Stonestreet Green Solar

Responses to First Written Questions (ExQ1)

PINS Ref: EN010135

Doc Ref. 8.11

Figure 1: Section of Fields 23, 24 and 26 – Southwest to Northeast

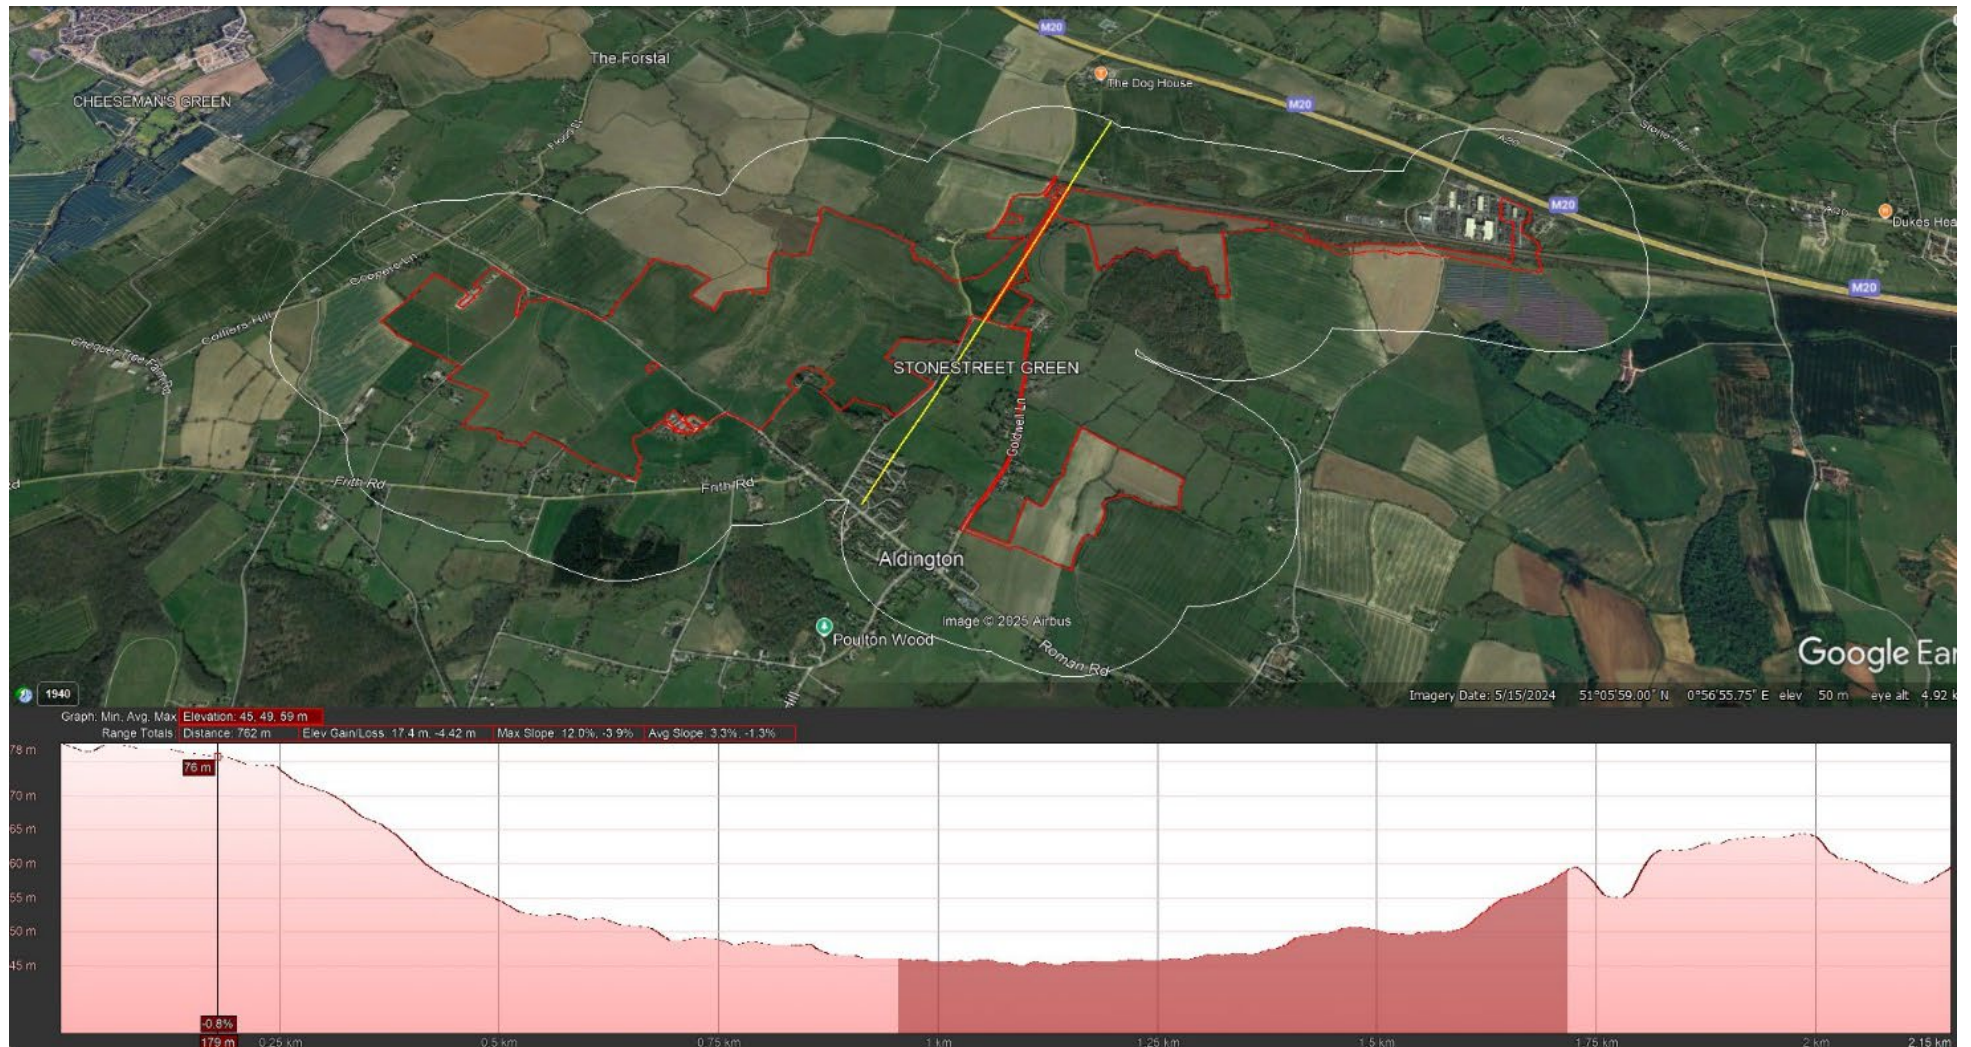
'Planning statement para 6.3.20 – suggests site is within a bowl – Could the Applicant provide a cross section to demonstrate this point'

1.1.4 Paragraph 6.3.20 of the **Planning Statement (Doc Ref. 7.6)** [[APP-151](#)] states *'The majority of the Site where solar arrays are proposed is within a 'bowl' in the landscape which aids in screening long range views'*. This statement acknowledges that there are parts of the Site that are not within the bowl.
